**Zoning By-law Amendment – Phase II of Low-rise Infill Housing:
Champlain Park Community Key Points to Planning Committee**

Meeting|: May 26, 2015

Equitable massing diagram

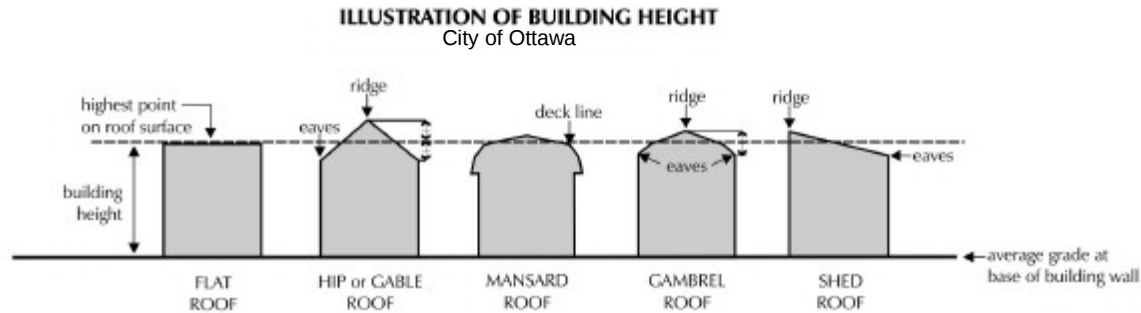
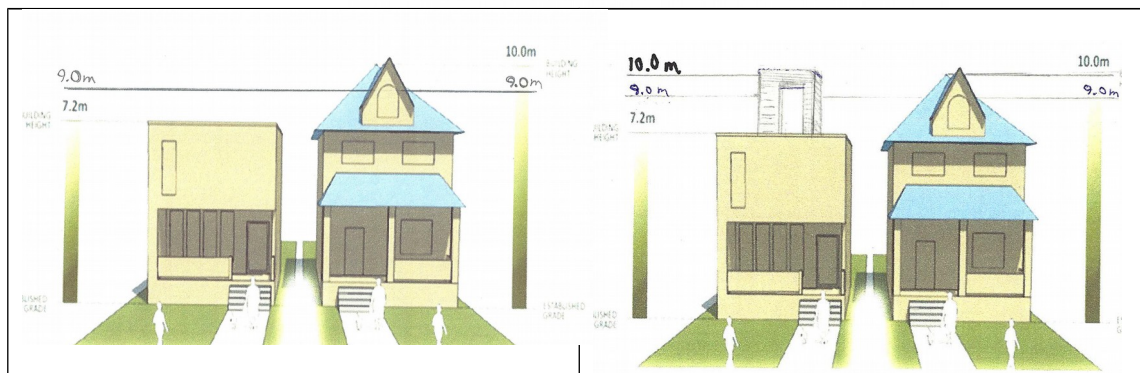
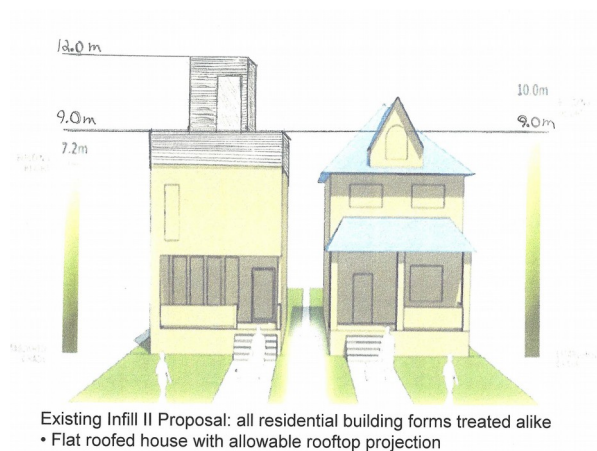
Champlain Park proposes that a working group be struck to study *Equitable Massing* as part of the Infill II By-law Monitoring and Review Process. The group's mandate will be to review the current method of calculating residential building heights, which, we understand, has not been reviewed for many years, and determine if an equitable massing model would improve the compatibility of new

infill development in Ottawa's communities. Diagrams describing equitable massing appear on page 4, *Appendix 2*.

What Equivalence could look like in Ottawa using an Equitable Massing Model.

Living space and massing are equivalent for flat and peak-roofed dwellings.

The rooftop access reflects the mass and height of the half-storey on the adjacent house, thus enhancing the flat-roofed dwelling's compatibility with the existing built form.
